SUBMISSION LODGEMENT / OBJECTION

State Significant Development SSD-89477725

**51-55 and 61 Parramatta Road
33, 35-41 and 43 Queens Road, Five Dock NSW 2046**

**Objection on behalf of:
Owners Corporation - Strata Plan 83068
49-51 Queens Road, Five Dock NSW 2046**

Figure 3. Building 1 upper-level plan excerpt. Appendix J1, PDF p.9, drawing 107 (GA Plan - Level 06-14), revision 28, 25 May 2026. The western dimensions are 9,300 mm and 10,670 mm. Reproduced excerpt, not to scale; use the complete architectural drawing for dimensional assessment.

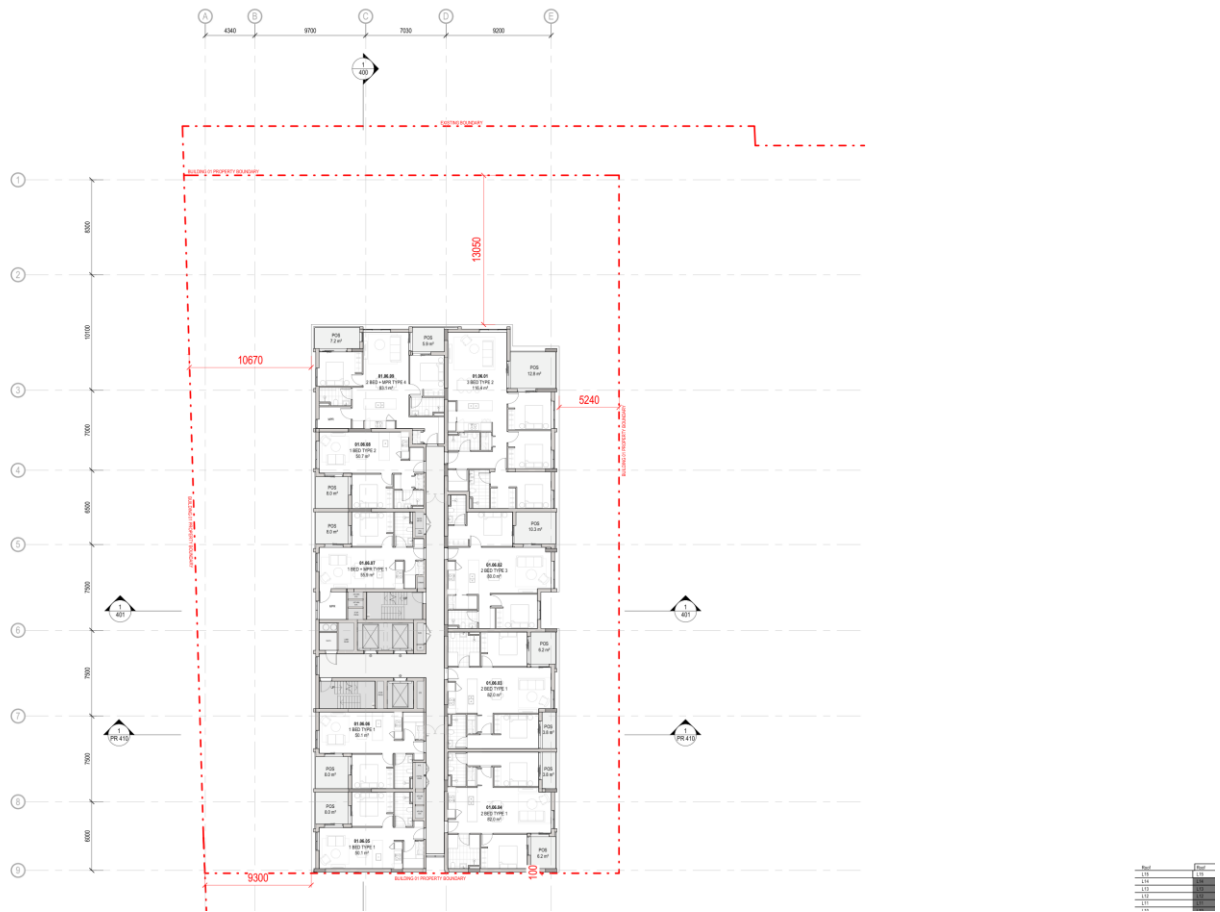
- Building 1 western setbacks are shown as 9.30-10.67 m on drawing 107. GANSW requested demonstration of a 12 m setback. Explain the allocation of separation across the boundary and demonstrate that any variation does not transfer an unreasonable design burden to the strata land.

architectural plan for Levels 06-14, drawing 107 revision 28 dated 25 May 2026, dimensions the relevant western distances as 9,300 mm and 10,670 mm. [EIS, pp.116-117; J1, p.9]

GANSW's second review advice, included in Appendix P, specifically asks the applicant to demonstrate that Building 1 meets the 12 m minimum setback to the neighbouring western development. The response in K-A instead supports 9 m above Level 8 on the basis of the western site's capacity to accommodate an approximately 1,000 m² upper-level plate and the balance of a 24 m separation. These are identifiable matters in the design review record, not new numerical controls invented by the objector. [P, p.21, item 17; K-A, p.35, item 17]

Appendix A9's 27.1 m building-to-building dimension may demonstrate that a particular illustrative layout can achieve more than 24 m overall. It does not answer why that allocation is appropriate, how it is distributed between the titles, or whether an alternative 12 m applicant setback would improve the strata site's usable envelope without unreasonable consequences. Both the total distance and its distribution need to be assessed.

The preferred response is to amend Building 1 to provide the relevant 12 m upper-level boundary setback identified by the design review, unless a site-specific alternative is independently demonstrated to satisfy the ADG objectives without unreasonable loss of amenity or development capacity on the strata land. Any alternative should be assessed with the Owners Corporation and GANSW, with its dimensional and performance basis recorded in the approved plans.
